Please consider this an observation submitted in response to the Newspaper Notice in the Connacht Tribune on 14/05/2026 related to Case Reference Number **ABP-320094-24**.

| <b>Project Description:</b>               | Proposed 400kV Gas insulated SwitchGear electricity substation and high voltage transmission lines/cables and electric plant. |
| <b>ABP/ACP Reference:</b>                 | ABP-320094-24                                                                                                                 |
| <b>Date:</b>                              | June 2026                                                                                                                     |

### 3.4 Integrated Interpretation

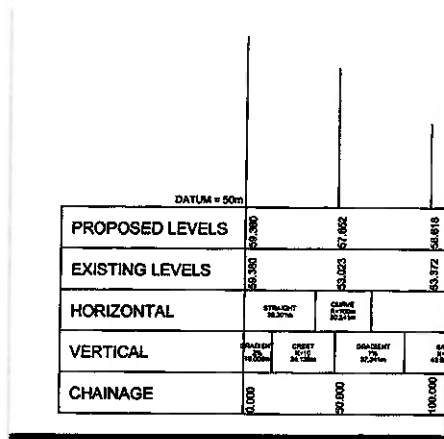
Such material is not suitable for general construction works so is certainly not suitable for this proposed development considering the large loading involved.

With this in mind, the developer's cut and fill calculations appear to be much too low.

**Figure 13.1 Site Location**

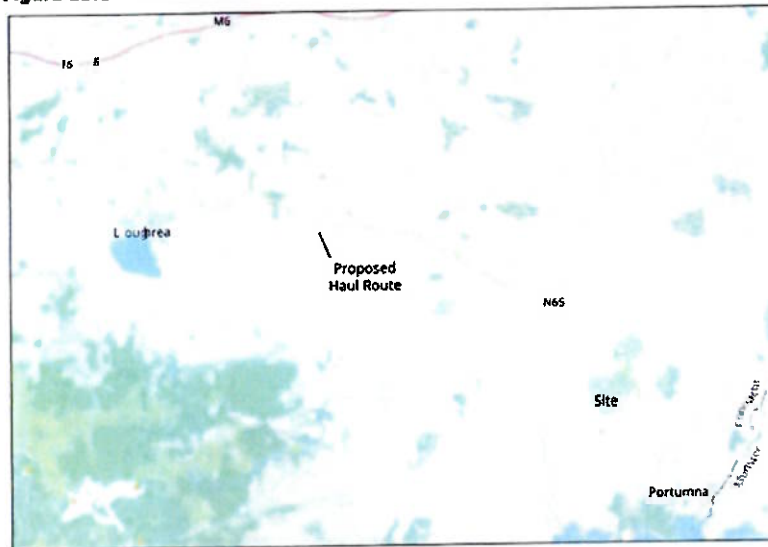
With the above in mind, I refer the planner to the developer's EIAR Addendum and its complete sidestepping of any traffic impact on the village of Killimor some 3.5km away from the proposed site and directly on the proposed haul route.

While the developer has noted the virtues of the proposed haul route avoiding travelling through the towns of Loughrea and Portumna<sup>43</sup>, it has completely ignored any impact on the village of Killimor. The oversight goes as far as ignoring Killimor on the traffic associated maps as can be seen below.

The closing paragraph of section 13.4 of the latest EIAR doubles down on this oversight. This is very curious given the regular references to Killimor when detailing the site location in other areas of the EIAR.

Figure 1.3 Indicative Gas Pipelines Routes

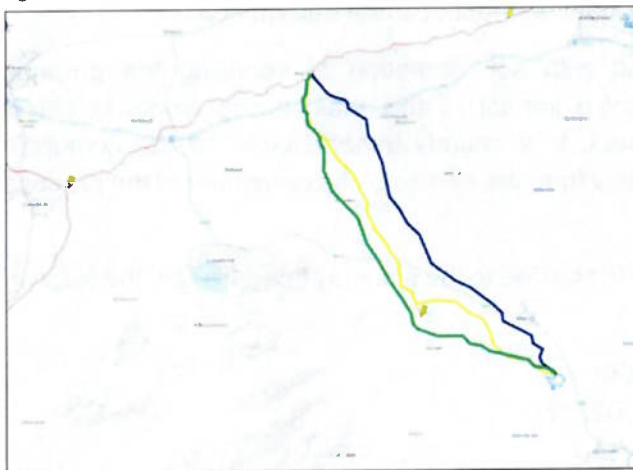
In the initial EIAR, the potential gas main routes were outlined on the drawing below<sup>50</sup>. The indicative route suggested a gas supply from the existing main in New Inn.

Despite all these substantial developments, the developer's latest EIAR has not in any way shape or form informed the planner of these changes. Furthermore, the proposed route is now well enough established that a full assessment of impact can be determined.

Proposed 100mm ID watermain connection shown green below

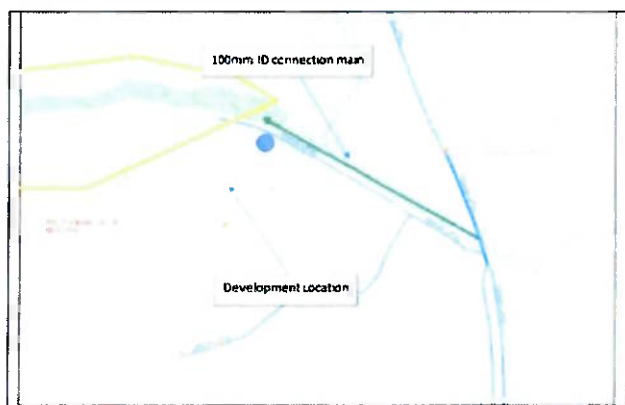
As part of the latest EIAR submission, the developer has submitted attachment D which relates to a proposed watermain connection joining an existing main on the N65 to the site. The drawing provided in attachment D is shown below.

Further to this, the Uisce Eireann letter attached in Attachment D refers to the existing Portumna water treatment plant which would potentially feed the site. That plant is currently at full capacity. Upgrade works are required to that plant to enable capacity to supply the site.
